ADDENDUM
NO. 2

May 28, 2020

Additions & Renovations to Lawrence Central High School
7300 E.56th St.
Indianapolis, IN 46226

ADDENDUM NO. 2
MAY 28, 2020

M. Sheet Number AR510

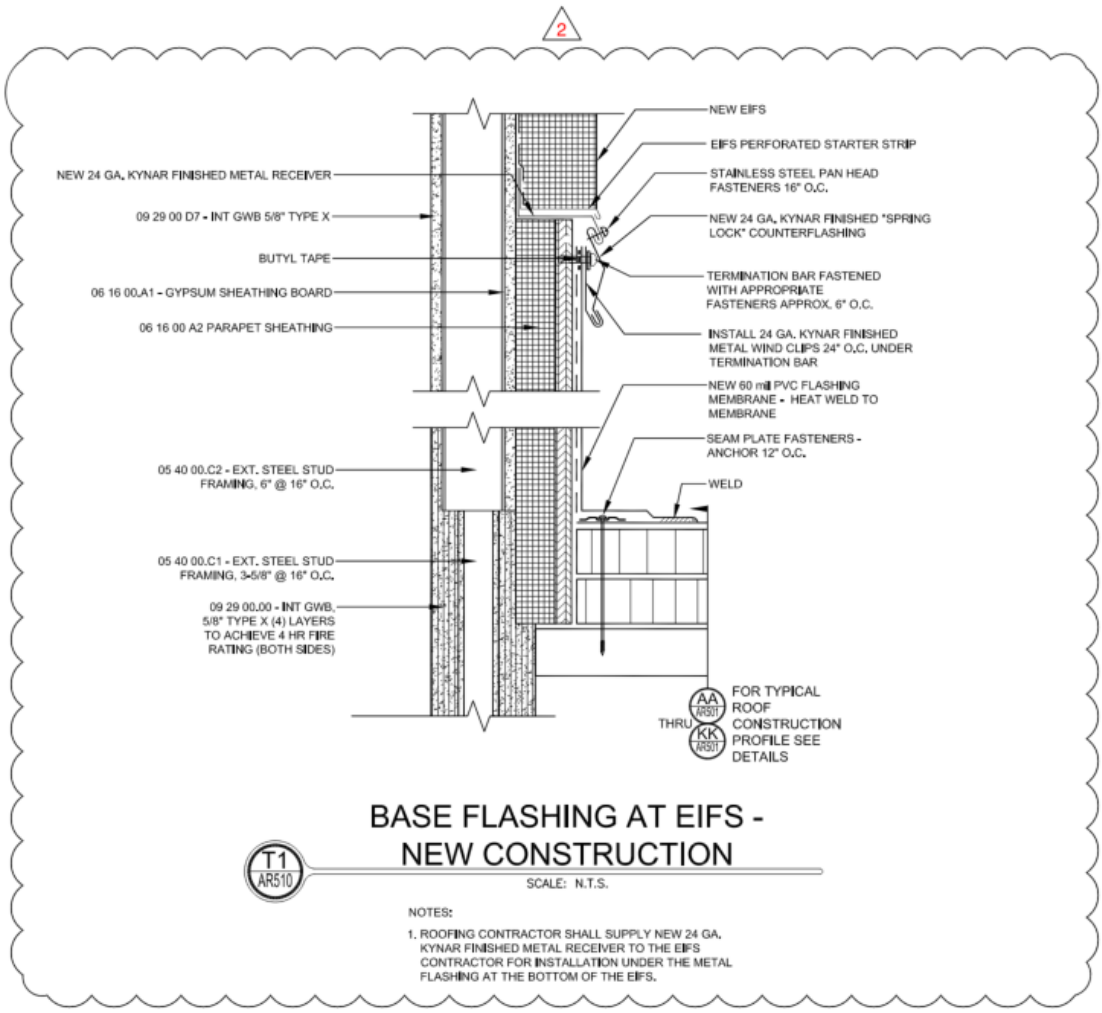
1. DELETE Drawing T1/AR510 and replace with the following:

N. Sheet Number A-210

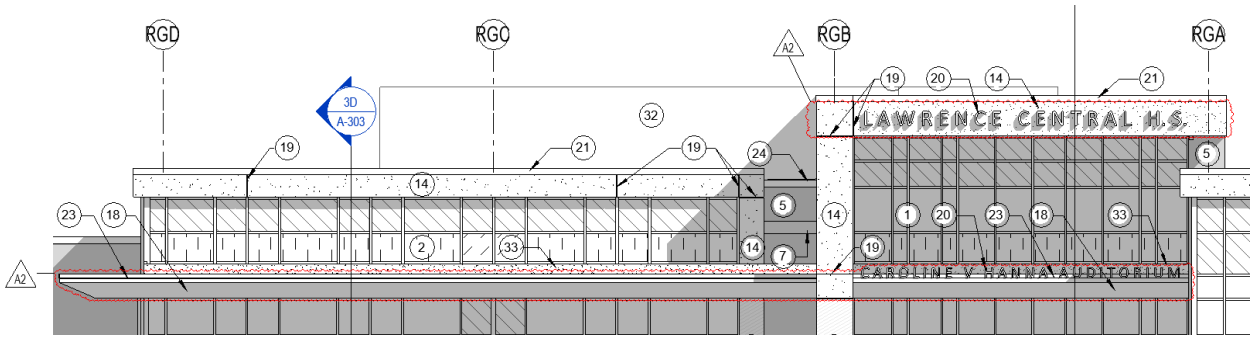
1. REVISE Drawing 1B/A-210 as indicated in the Drawing below:

O. Sheet Number A-211

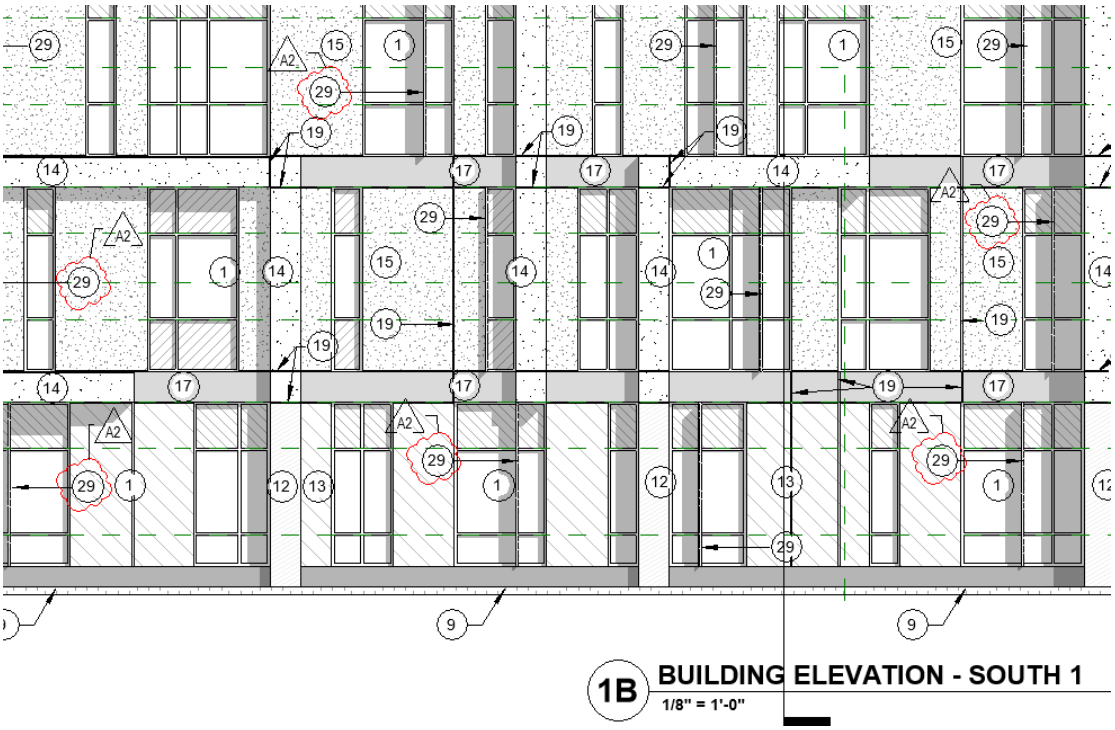
1. REVISE Drawing 1B/A-211 to add Elev. Note 29 as indicated in the Drawing below:

P. Sheet Number A-212

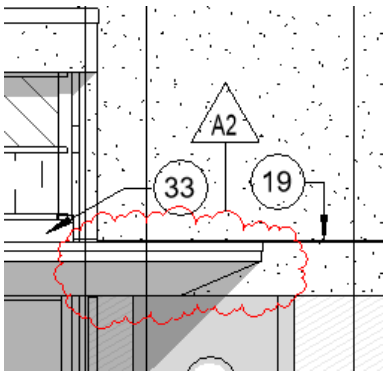
1. REVISE portion of Drawing 6E/A-212 as indicated in the Drawing below:

R. Sheet Number A-603

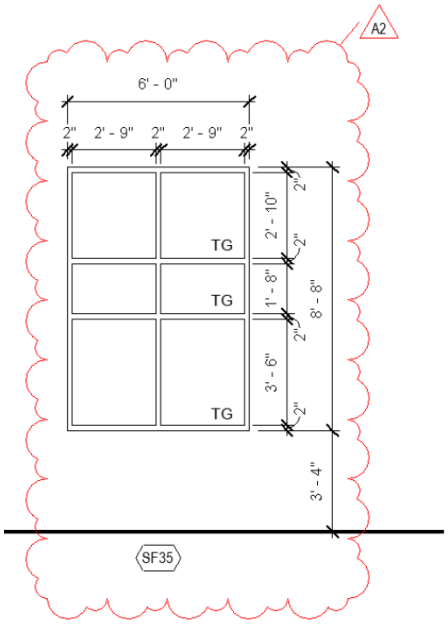
1. ADD Storefront Elevation SF35 to the sheet as indicated below:

J. Sheet Number IN1K1

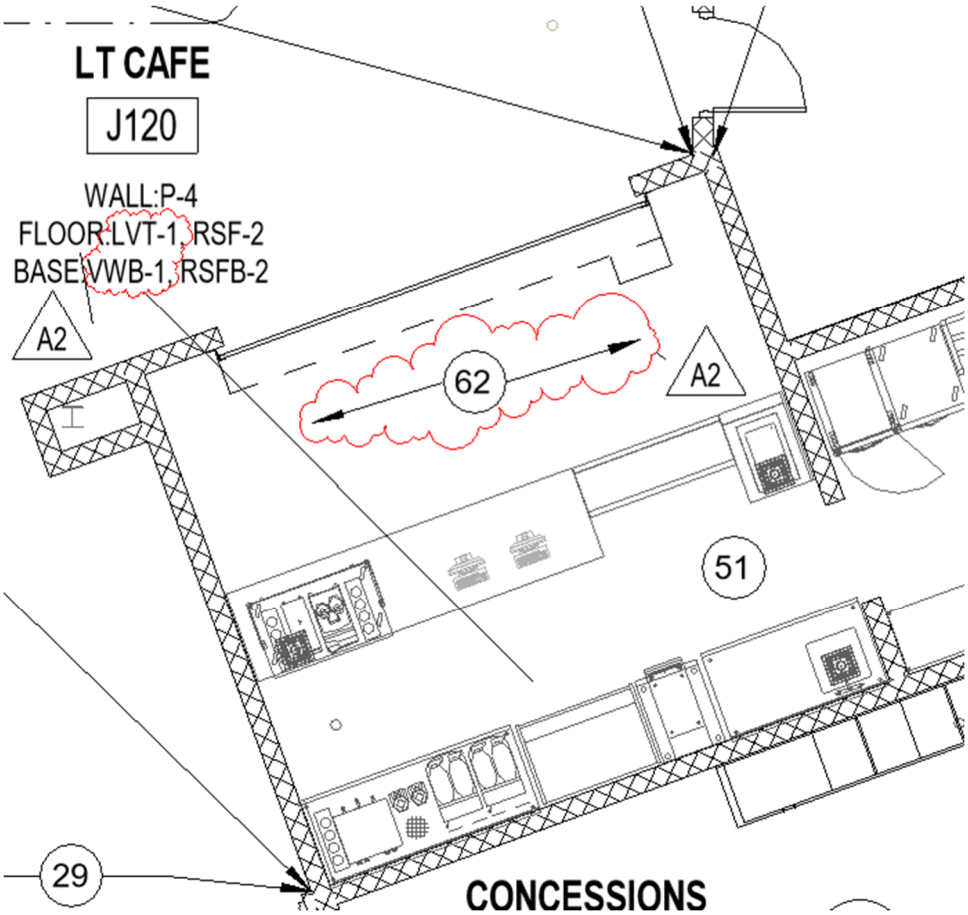
1. DELETE AND REPLACE Note 29 with Note 61 in Service Kitchen K118.
2. MODIFY finish tag and add Note 62 as shown below:

1A ORCHESTRA INSTRUMENT STORAGE ELEVATION 1_CD
1/4" = 1'-0"

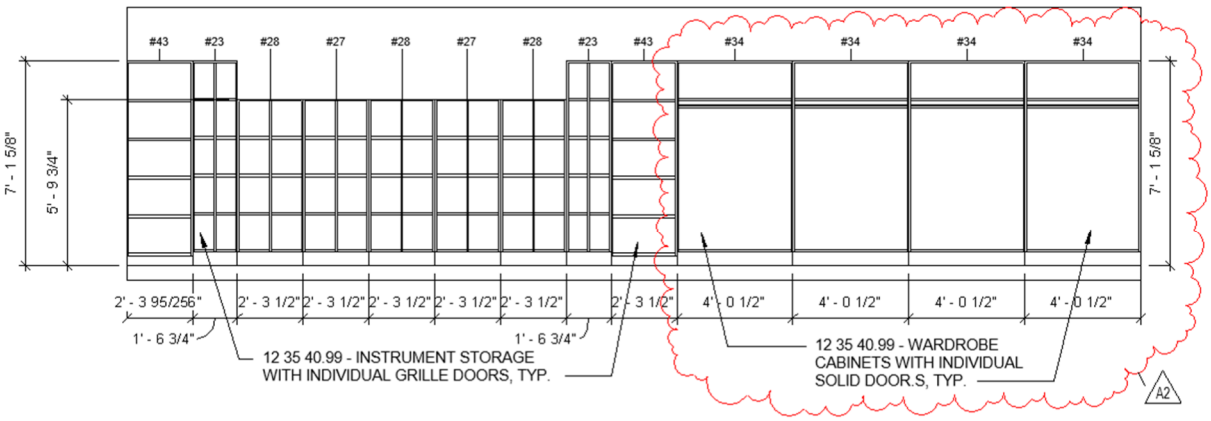
1. MODIFY Elevation 1A as shown below:

1B ORCHESTRA INSTRUMENT STORAGE ELEVATION 2_CD
1/4" = 1'-0"

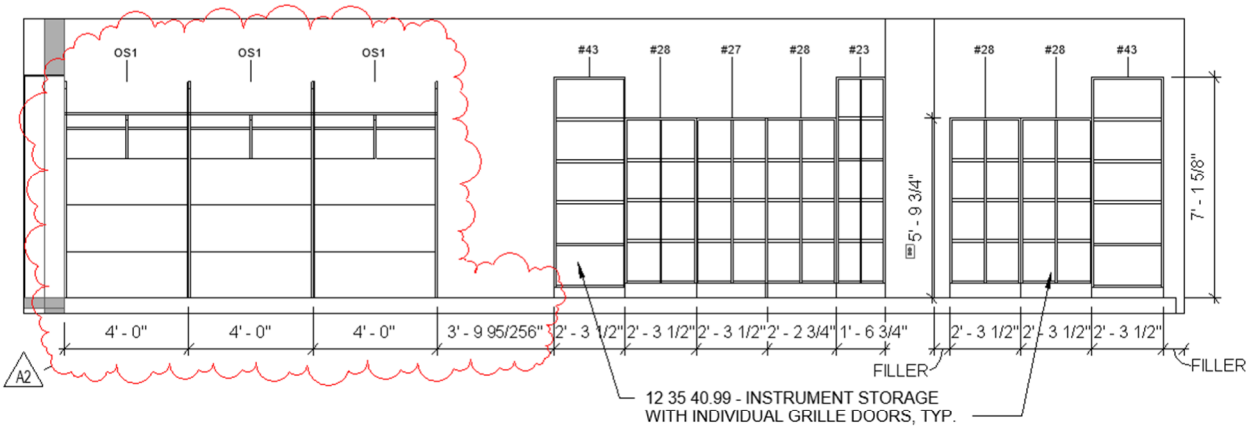
2. MODIFY Elevation 1B as shown below:

K. Sheet Number I-204

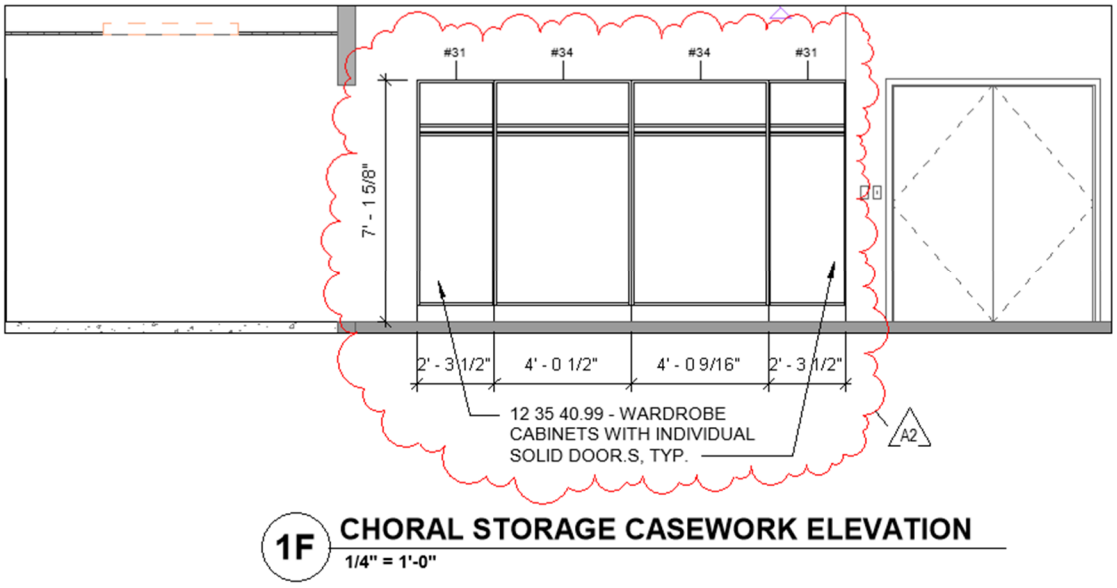
3. MODIFY Elevation 1F as shown below:

L. Sheet Number I-403

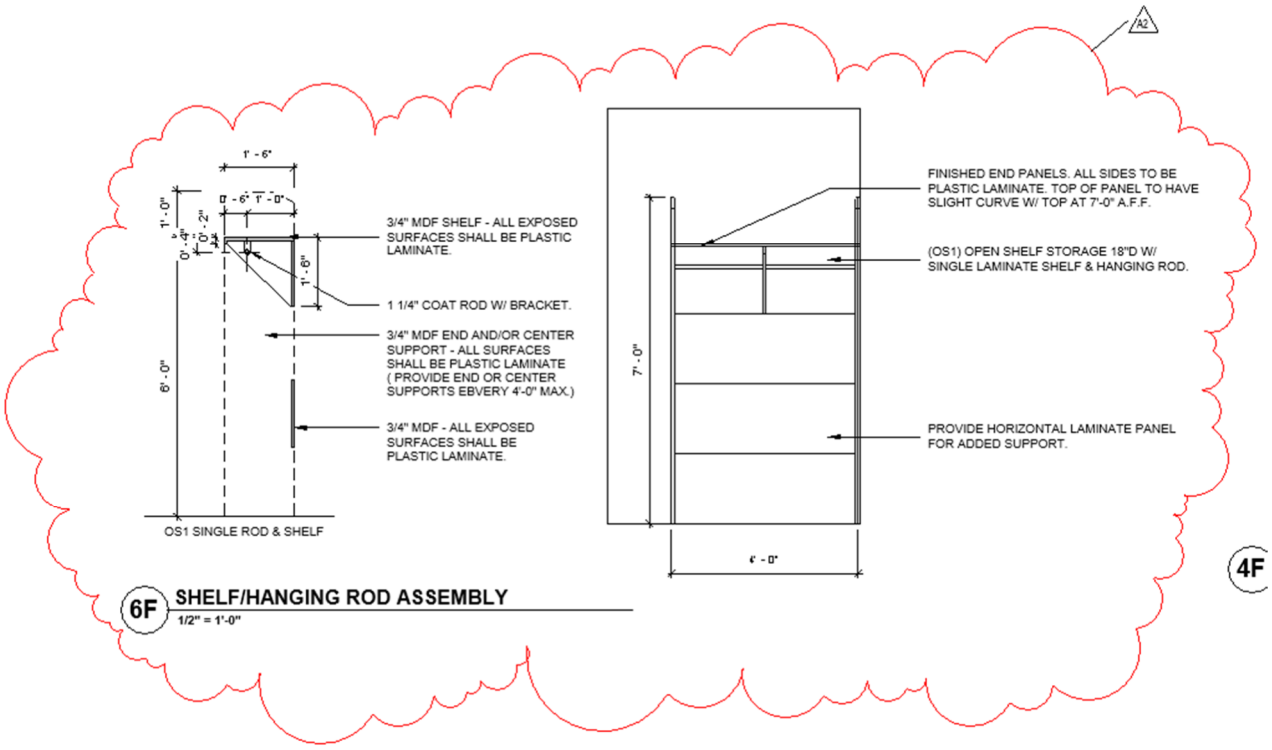
1. ADD Detail 1F as shown below:

B. Sheet Number MH1A1

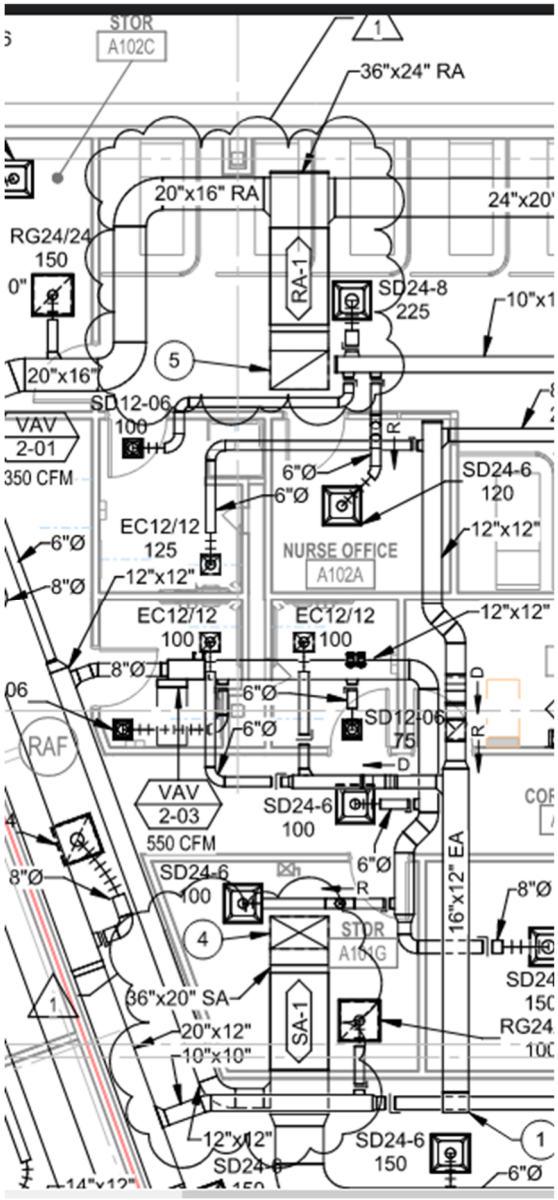
1. ADD duct silencers SA-1 and RA-1 to RTAHU-2 duct system as follows:

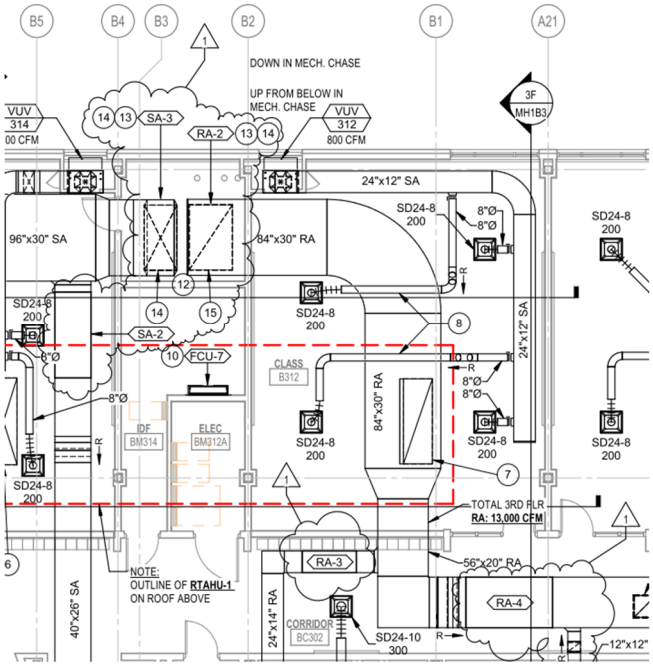
2. ADD duct silencers SA-2, SA-3, RA-2, RA-3, RA-4 to RTAHU-1 duct system as follows:

C. Sheet Number MH1B1

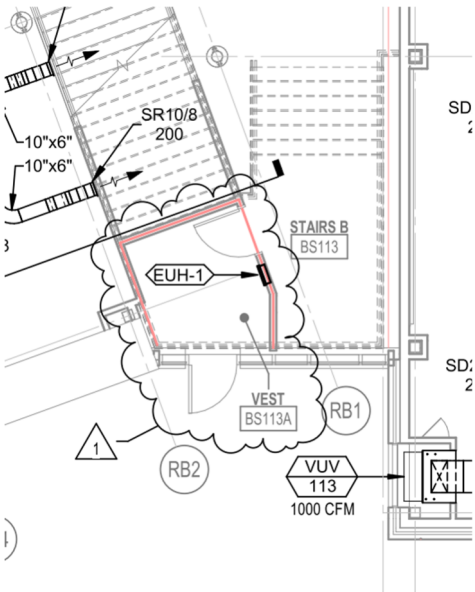
1. ADD installation of electric wall heater EUH-1 to Vest BS113A as follows:

D. Sheet Number MH1F1

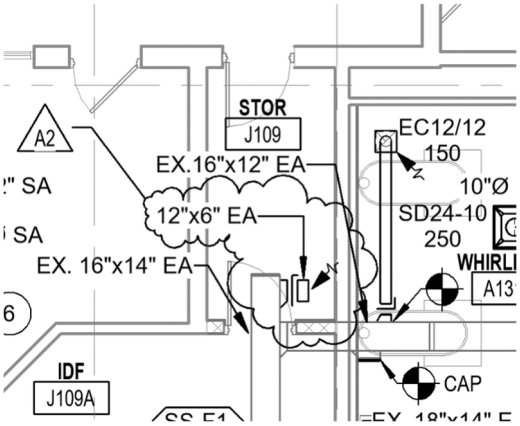
1. ADD 50 CFM of exhaust air ducted from room J109 as follows:

F. Sheet Number MH1J1

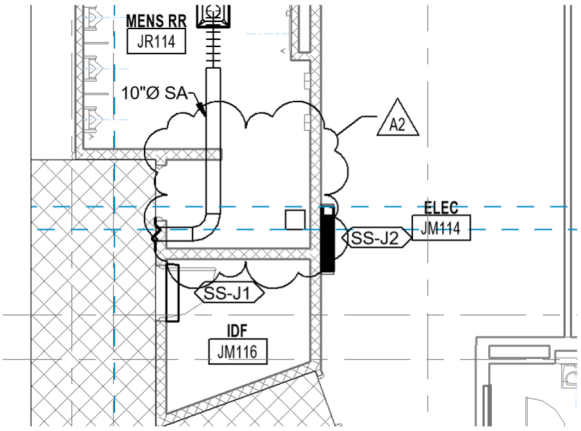
1. MODIFY supply branch ductwork by eliminating supply ducts to rooms JM116 & JM114 as follows:

G. All HVAC Sheets: Sheet Number MH1A1 - MH1B3

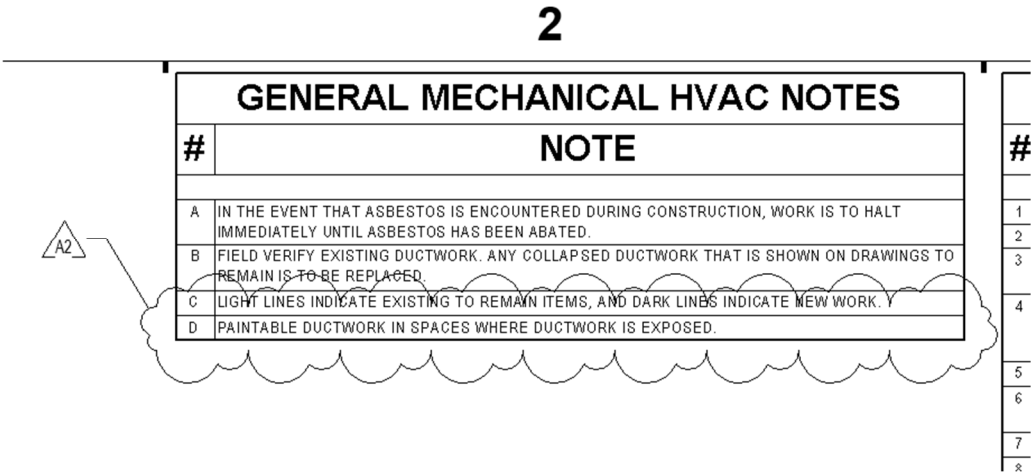
1. ADD General Note D as follows and shown below:

"D. Paintable ductwork in spaces where ductwork is exposed."

H. Sheet Number MH1D1

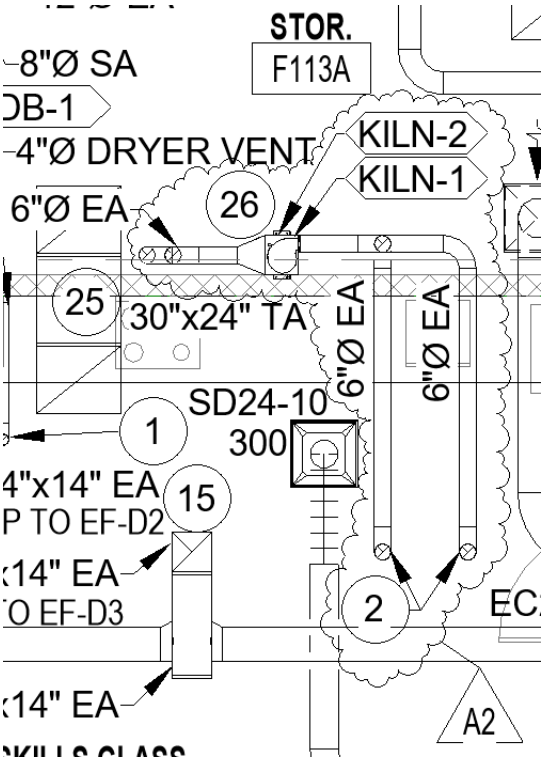
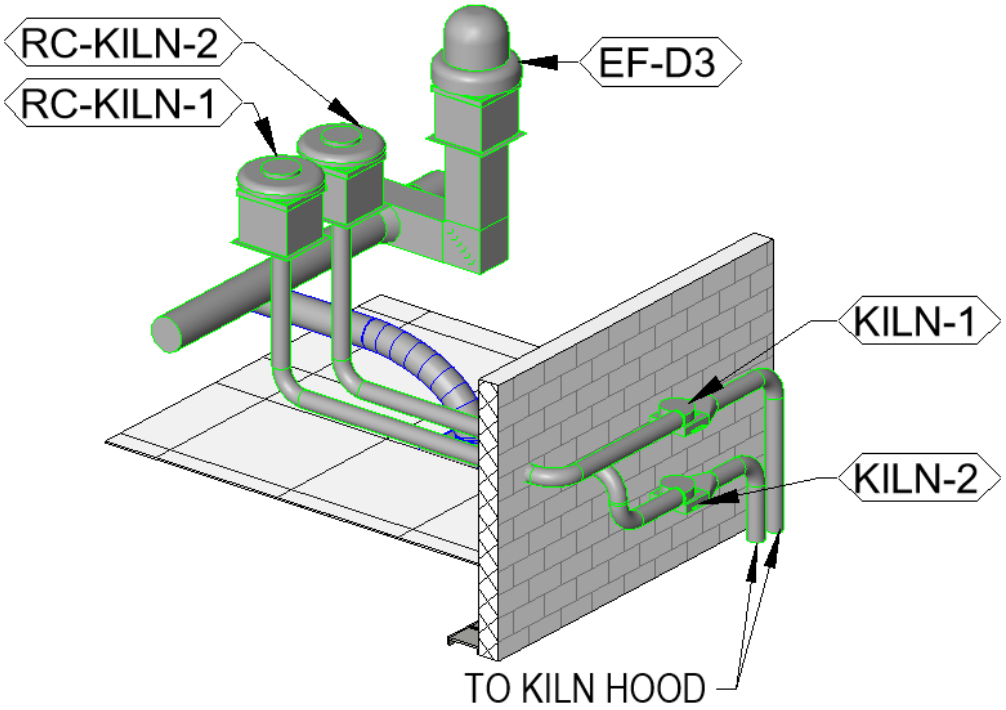
1. MODIFY Kiln area HVAC to add a second Vent-a-kiln hood and revise hood exhaust fans per the following three plan revision clips:

26	ROUTE KILN EXHAUST DUCT TO KILN HOOD. TYP 2. SEE DETAIL 1E/M-503. SEE ISOMETRIC VIEW 7E ON THIS SHEET.

I. Sheet Number MP1F1

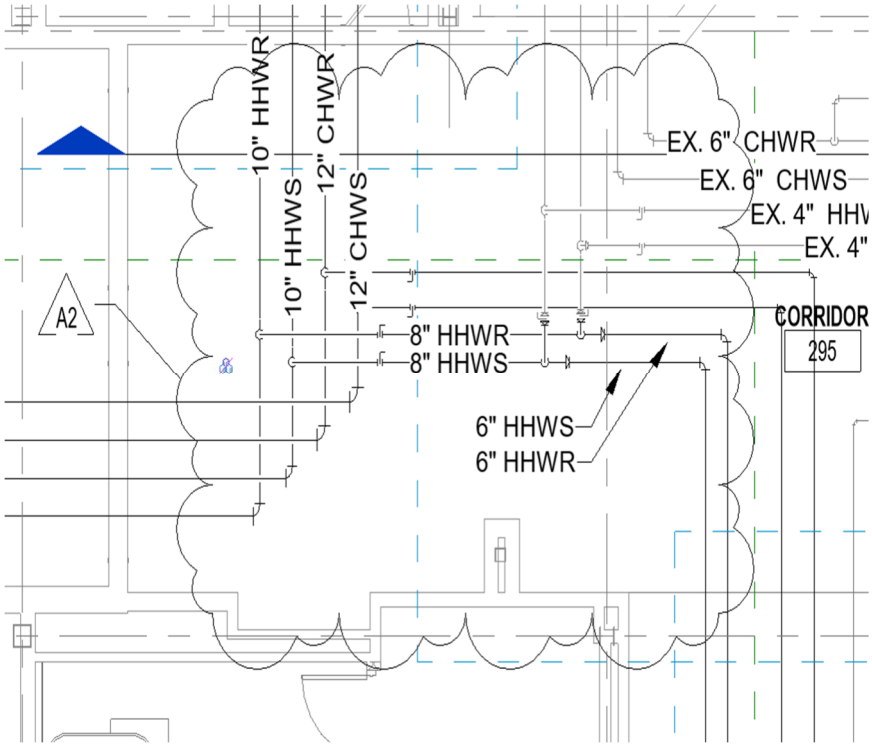
1. MODIFY heating water piping by increasing branch piping size to 8” and tie in existing field house piping as revised in the following sketch:

J. Sheet Number MR102

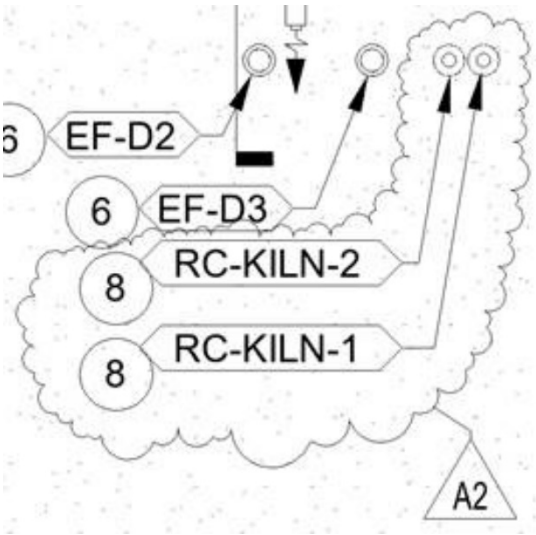
1. ADD RC-KILN-2 as revised in the following:
